Access Compliance Report

Public Rights-of-Way

(Curb Ramps)

Intersection ID: 9325	Main Street: FREEDOM_DR	Cross Street: MARLENE_ST	Location: NW
ADA ID: 4CF0FEFCC130	Ramp Type: Perp	Initial Pass/Fail: Fail	Overall Compliance: No
Severity Score: 10			
Codes/Mitigation Info/Possible Solution		Field Measurements/Component Compliance

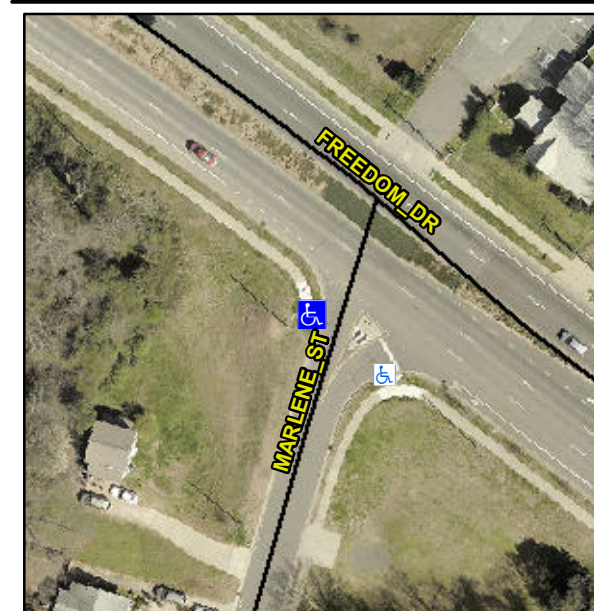
Not Found, R304.5.1, R304.5.3

Compliance	Description	Data	Compliance	Description	Data
N/A	Ramp Length (in)	59.0	Yes	Ramp Slope (%)	5.8
No	Ramp Width (in)	47.5	No	Ramp XSlope (%)	5.0
N/A	Flare Type LT	N/A	N/A	Flare Type RT	N/A
N/A	Flare Slope LT (%)	N/A	N/A	Flare Slope RT (%)	N/A
N/A	Flare Traversable LT?	N/A	N/A	Flare Traversable RT?	N/A
N/A	Landing Length (in)	N/A	N/A	DWS Provided?	N/A
N/A	Landing Width (in)	N/A	N/A	DWS Contrast?	N/A
N/A	Landing Slope (%)	N/A	N/A	DWS Length (in)	N/A
N/A	Landing X Slope (%)	N/A	N/A	DWS Full Width?	N/A
N/A	Landing Curb? (Y/N)	N/A	N/A	DWS Offset (in)	N/A
N/A	Shared Landing?	N/A			
N/A	Gutter Ponding?	N/A	N/A	Gutter Slope (%)	N/A
N/A	Gutter Lip Ht (in)	0.5	N/A	Gutter X Slope (%)	N/A
N/A	Painted X Walk1?	No	N/A	Painted X Walk2?	N/A
	X Walk 1 Direction	To SE		X Walk 2 Direction	N/A
N/A	X Walk 1 Width (in)	N/A	N/A	X Walk 2 Width (in)	N/A
	X Walk 1 Slope (%)	0.7		X Walk 2 Slope (%)	N/A
	X Walk 1 X Slope (%)	4.4		X Walk 2 X Slope (%)	N/A

Remove & Replace Entire Ramp.
